D-03  
EXHIBIT 'C'

G-2 QUANTITY	G-1 ITEM NO.	ITEM NO.	DRAWING NO.	DESCRIPTION	PROJECT NO.	USED ON ASS'Y
TOLERANCES UNLESS OTHERWISE SPECIFIED			APPROVED	DATE	FINISH & SPECIFICATION	TITLE
DECIMAL	± .005		DRAWN	12-27-59	MATERIAL & SPECIFICATION	STORAGE RACKS FOR FINISHED PINS
FRACTIONAL	± 1/64"		CHECKED			
ANGULAR	± 1/2°		APPROVED	12-28-59		
BREAK ALL SHARP EDGES REMOVE ALL BURRS			ENGELHARD INDUSTRIES INC. D. E. MAKEPEACE DIVISION ATTLEBORO, MASS.		SCALE NONE	SIZE C DRAWING NO. 50034 REV. A

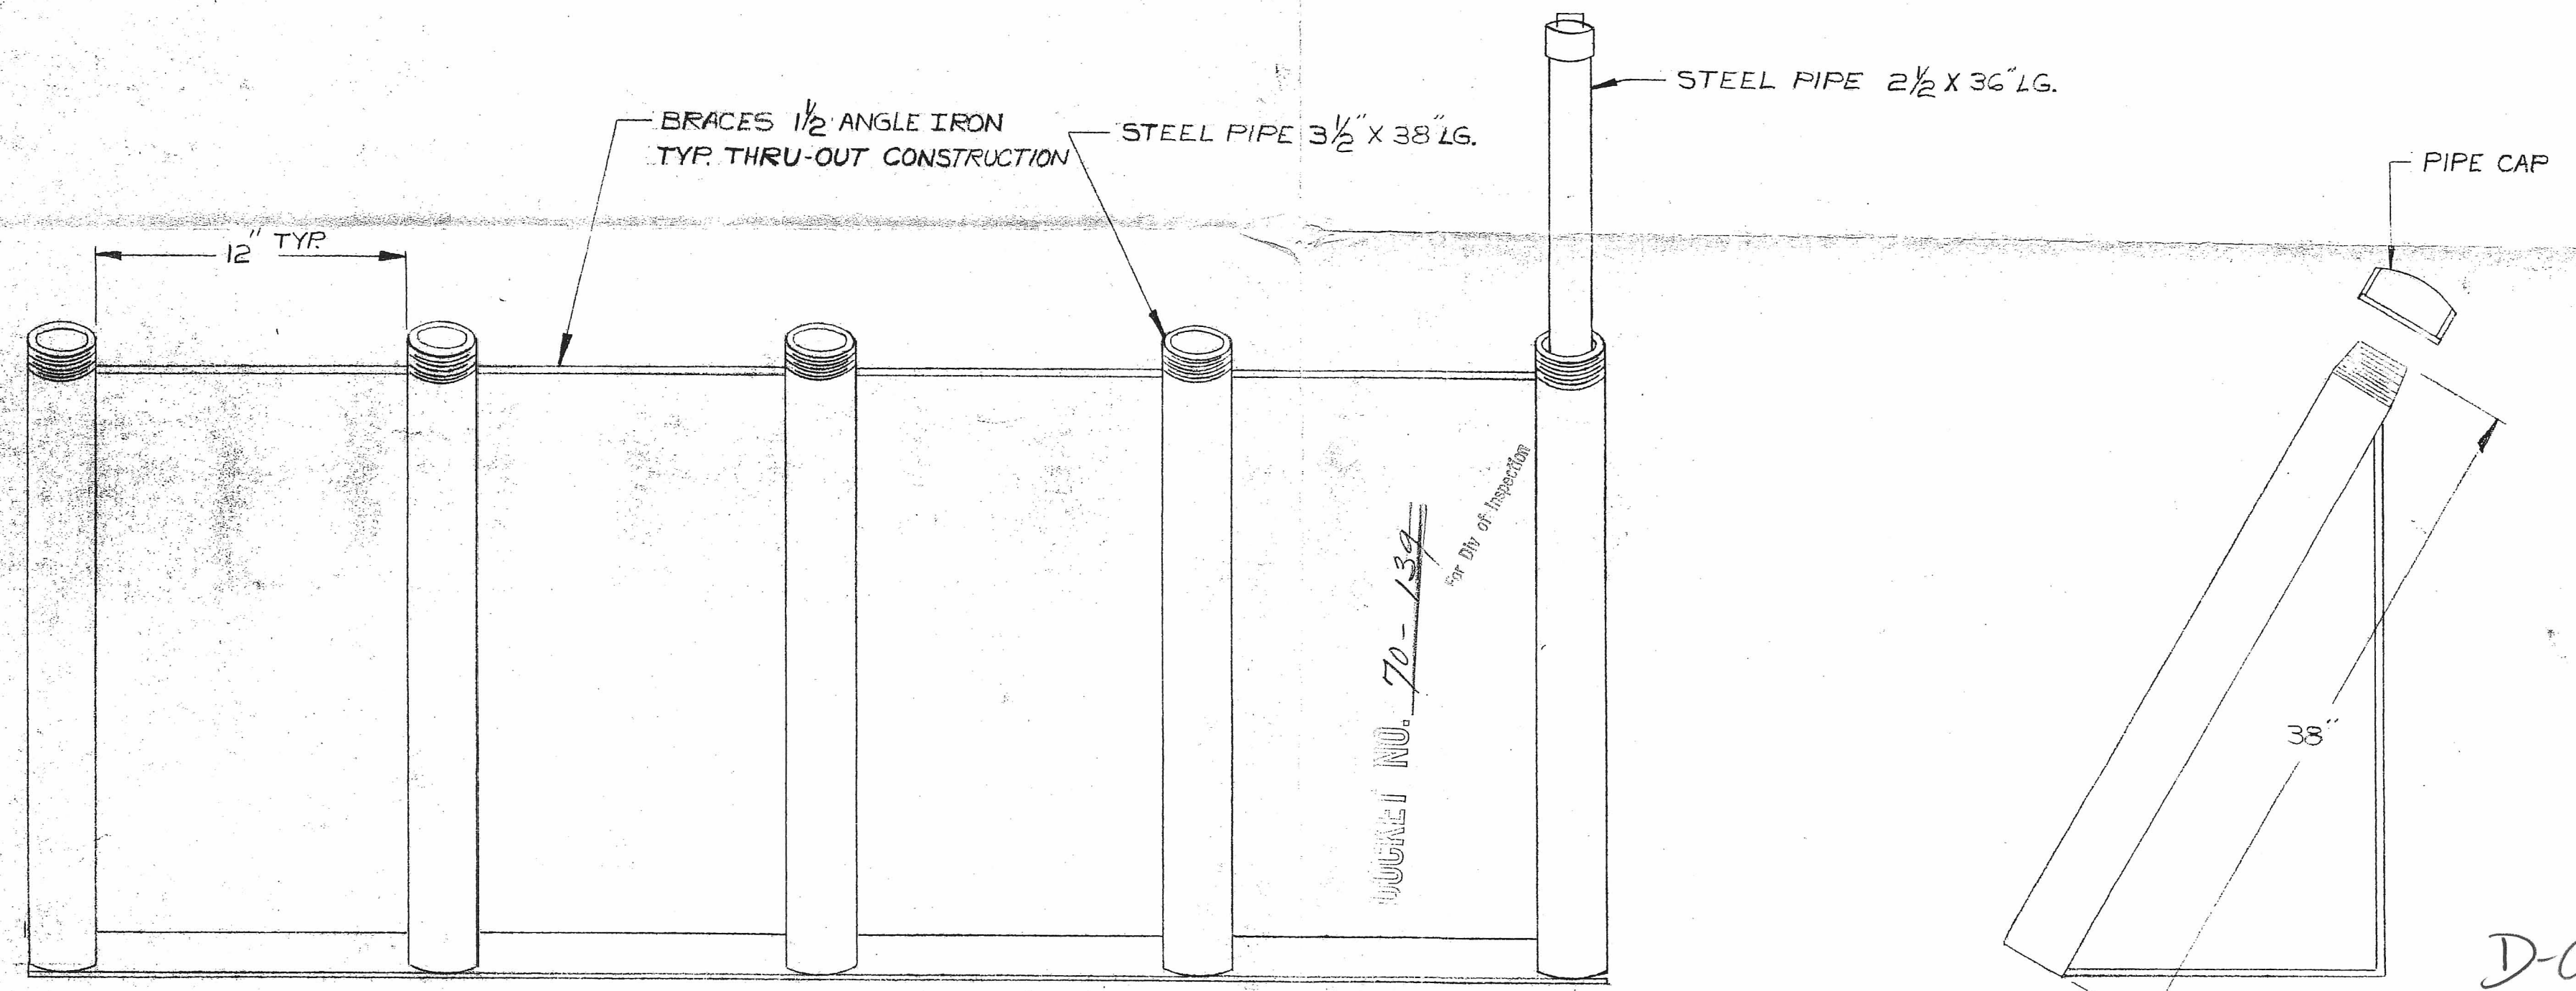
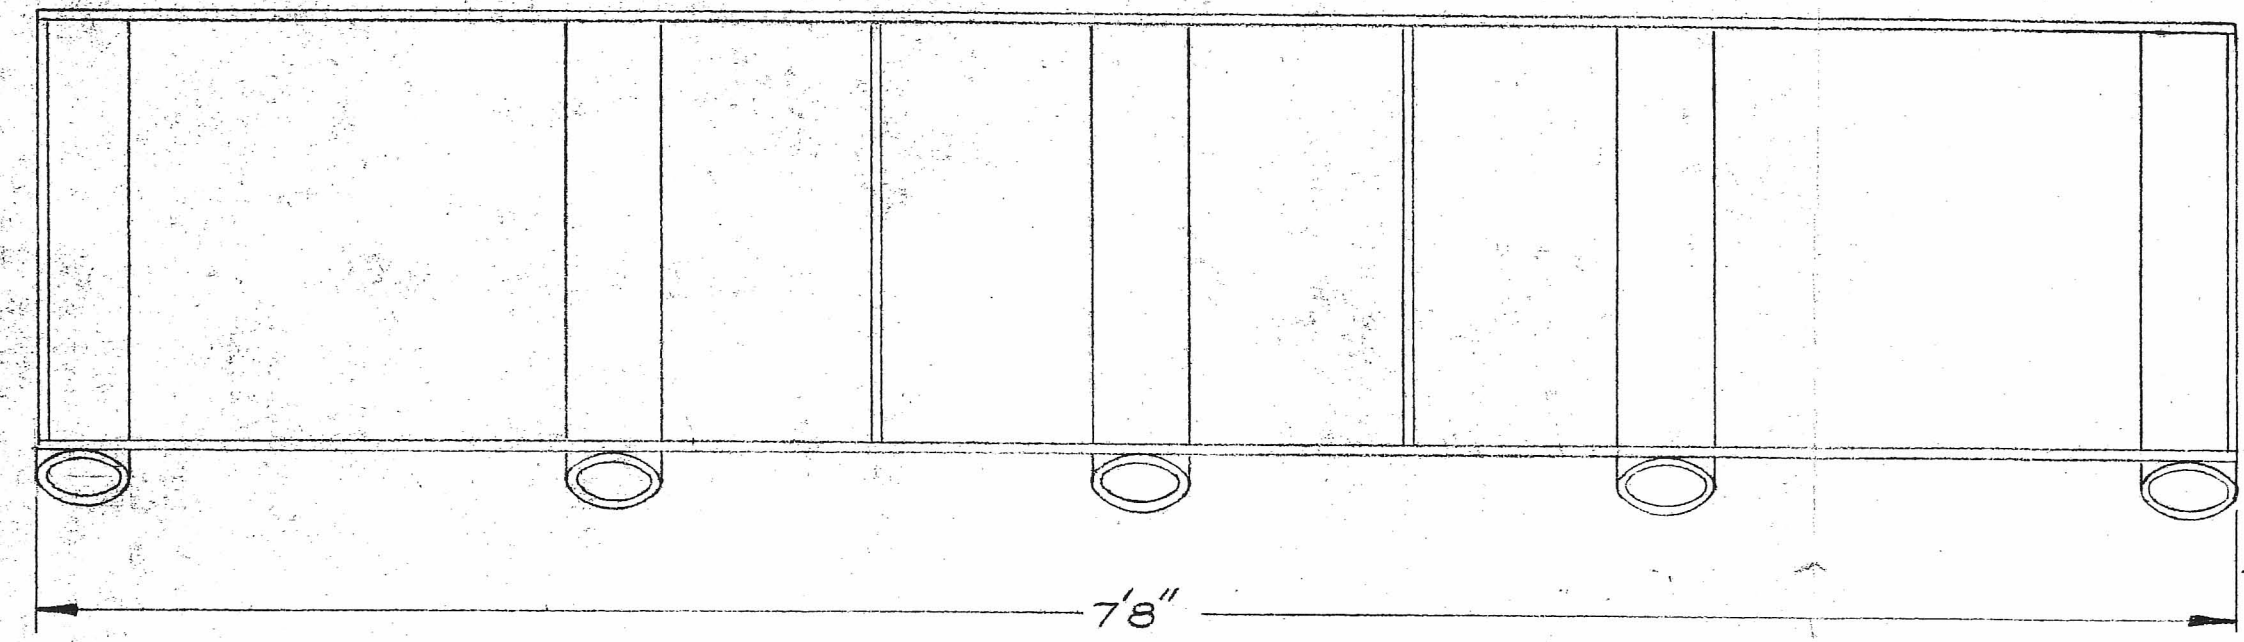
CHG. LET.	DESCRIPTION	DATE	BY	APP.	CHG. NO.
A	REMOVED CADMIUM LINER CHANGE TUBE SPACING TO 12" CHANGE BRACE FOR FLOOR MOUNTING	3/10/60	AJF		147
